1/2" Legacy Quick Dump Valve Product Line Obsolescence Update

PRODUCT INFORMATION BULLETIN | PIB 115-020317-002

Obsolescence of Gilmore 1/2" Legacy Quick Dump Valve Repair Kits, Seal Kits, and Aftermarket Repair Support

Figure 1. PN 29010: 1/2" NPT Quick Dump Valve

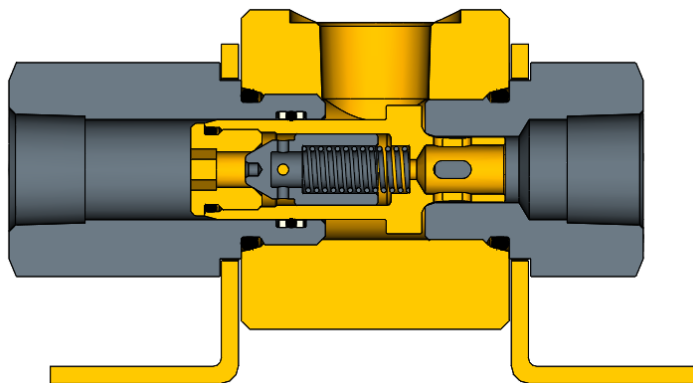
- Nitronic 60 Spool with self-centering metal seat geometry
- Nitronic 60 Poppet
- Nitronic 60 Seat with O-Ring seal

The new Gilmore 1/2" Quick Dump Valve product line offers the following enhancements over the legacy product line:

- Field repairable
- Elimination of the need to coin each valve
- Meets the latest Proserv Gilmore material specifications
- Fits the same footprint as the legacy Gilmore 1/2" Quick Dump Valve
